#### PLANNING COMMISSION WORK SESSION AGENDA CITY OF PRAIRIE VILLAGE TUESDAY, APRIL 2, 2013 \*\*INDIAN HILLS MIDDLE SCHOOL"" 6400 MISSION ROAD

Presentation on proposed development of 8500 Mission Road 
"Mission Chateau Senior Center
Representatives of Tutera Family Communities &
Polsinelli Shughart

Mission Chateau Traffic Impact Study Review

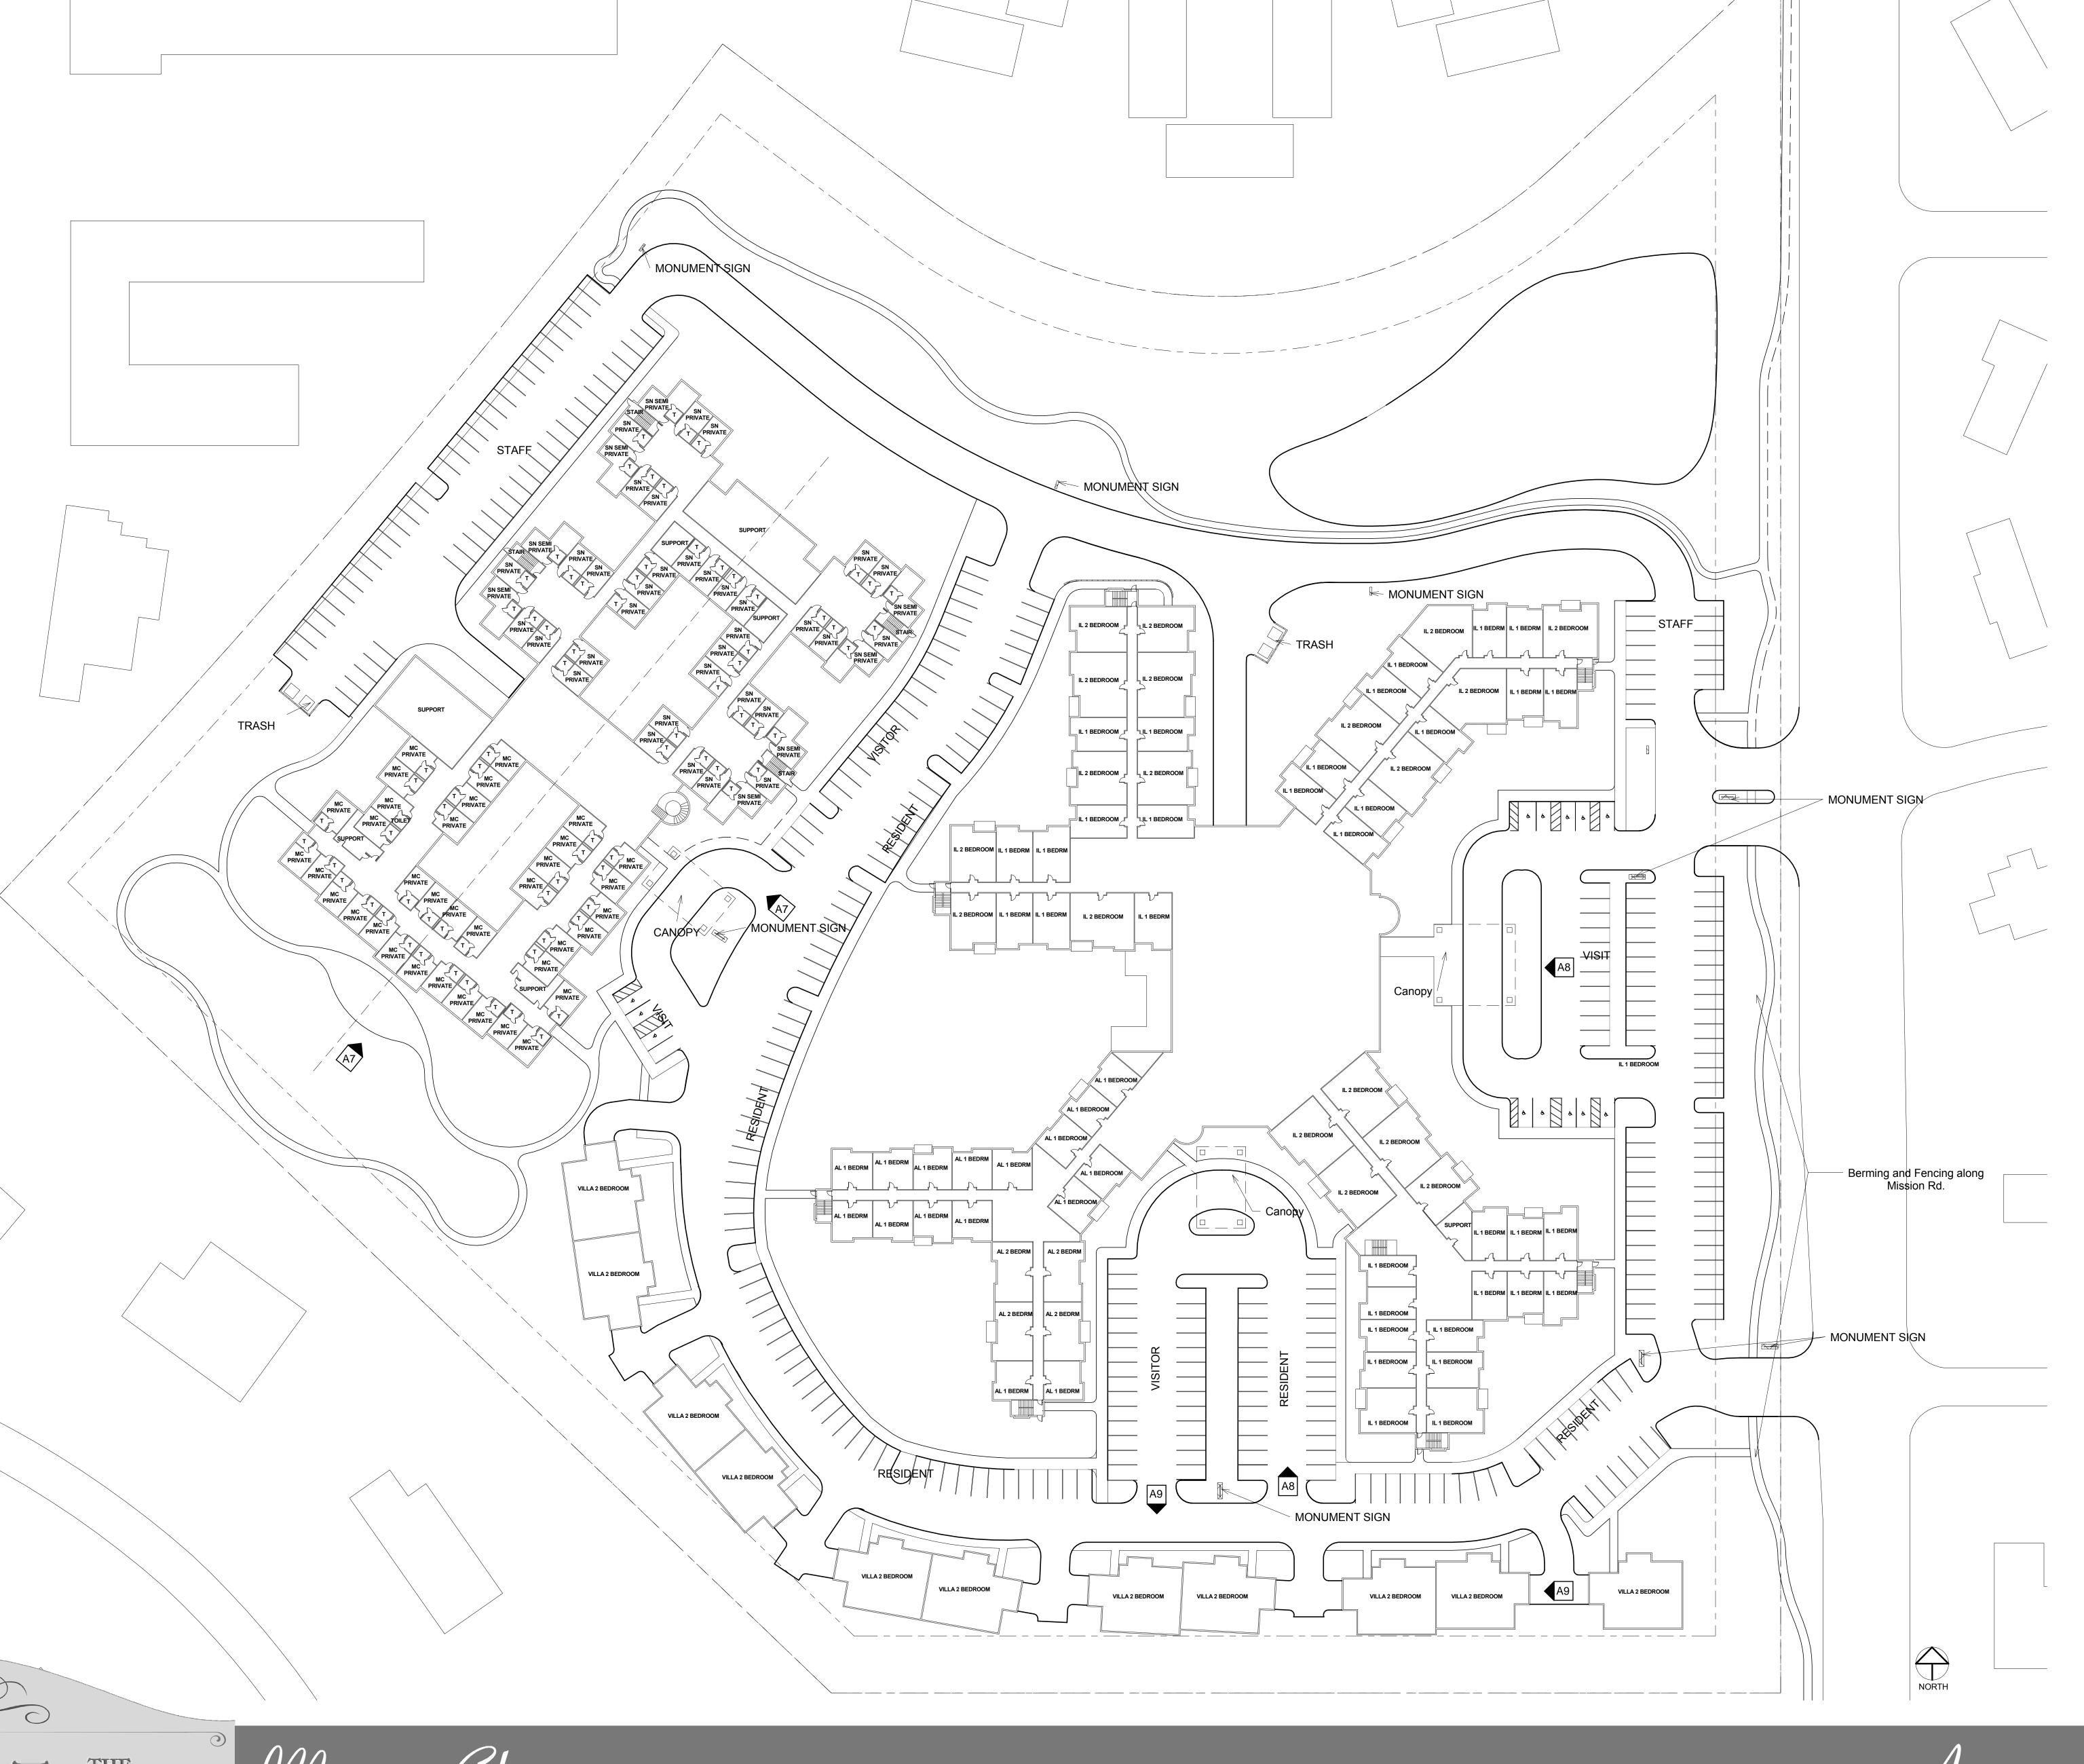
- 2. A new driveway is proposed across from 85th Street. There was no mention of available sight lines along Mission Road from this point. The study should include an evaluation based on current and proposed conditions. I did note some large trees behind the Mission Road sidewalk near the south property line. Similarly, sight lines at the north driveway should be assessed relative to proposed conditions. Berms are proposed, but not detailed, between the street and parking lot.

5. The length of the throat of both site driveways is about 60 feet (it's difficult to know for certain since the curb line of Mission Road isn't clearly shown). Driveway throats should be at least 100 feet off of an arterial street for two main reasons - to store exiting traffic and to provide a transition for entering traffic. The relatively modest traffic volumes anticipated with this development suggest the shorter throat lengths could function adequately but provisions should be made to clearly give inbound traffic the right-of-way at the first intersection on the site. This would include stop-sign control of the other approaches and providing signage for inbound drivers (similar to what is used on many shopping center entrances).

6. The design of each end of the raised median on the northern most driveway should be modified to accommodate reasonable turning radii. In particular, the west end of this median should not extend to the very edge of the intersecting driving aisle. Final placement of sidewalk along Mission Road could influence the design of the east end of this median.

8. Curvilinear sidewalk is proposed along Mission Road. The separation between Mission Road and the sidewalk on each site driveway is quite significant. I would encourage you to place these relatively close to Mission Road (5 to 8 feet) so pedestrians are visible to turning traffic and pedestrians don't have to cross behind outbound traffic stopped on the driveway. Bear in mind that exiting drivers will pull up very close to Mission Road in order to maximize their view of oncoming traffic and to lessen the time they are exposed to conflicting traffic as they turn.

- 9. Sidewalk is proposed around the footprints of the two main buildings but it is incomplete. Further, there is no continuity across the two major driveways associated with the building closest to Mission Road. There is no sidewalk along the side of the interior drive where the villas are proposed.
  The site layout was revised to make accommodations for this comment.
- 10. It would be preferable to have one-way traffic flow at each of the three major building entrances. Using angle parking where feasible would help reinforce the appropriate travel path.

11. The curve in the driveway at the northeast corner of the site is very tight. Virtually every driver will encroach into the opposing lane while navigating this curve, particularly traffic traveling towards the back of the site. The inside radius appears to have been abbreviated for parking. That radius should be developed fully and perhaps even increased somewhat.

12. Parking along a curvilinear driving aisle is problematic in that viewing distances for drivers in the aisle and drivers unparking will be limited. It is important to maintain a low-speed environment to minimize potential conflicts. One way to accomplish that would be by constructing raised crosswalks at strategic locations; in essence a traffic calming strategy.

13. The abundance of parking along driving aisles, as well as the curvilinear alignment and tight curves, makes it essential that sight lines be protected. Careful placement of potential obstructions such as landscaping and signage is critical.

- Prior to final design, sight distance requirements must be reviewed and meet or exceed requirements set forth by AASHTO. Report updated.
- 3. The report notes that the two site driveways will align with 84th Terrace and 85th Street on the east side of Mission Road. Neither the traffic study nor the site plan shows the existing public streets to the east in sufficient detail to judge the alignments. It's important to specify that now to provide sufficient guidance to the designer. Absent a topographic survey, I'd suggest that the center lines of the driveways align with the center lines of the public streets on the opposite side of Mission Road.
  Sight drive alignment is now depicted on the site plan to align with the center of the adjacent streets.

The traffic study now includes recommendations for internal drive signing at the two main entrances. Entering traffic shall have the right-of-way with northbound and southbound traffic stop controlled.

The site layout was revised to make accommodations for this comment.

The site layout was revised to make accommodations for this comment. Sidewalks cross entrances much closer to Mission Road now.

This recommendation is currently under evaluation for future plans.

The site layout was revised to make accommodations for this comment.

The site layout was revised to make accommodations for this comment.

The site layout was revised to make accommodations for this comment.
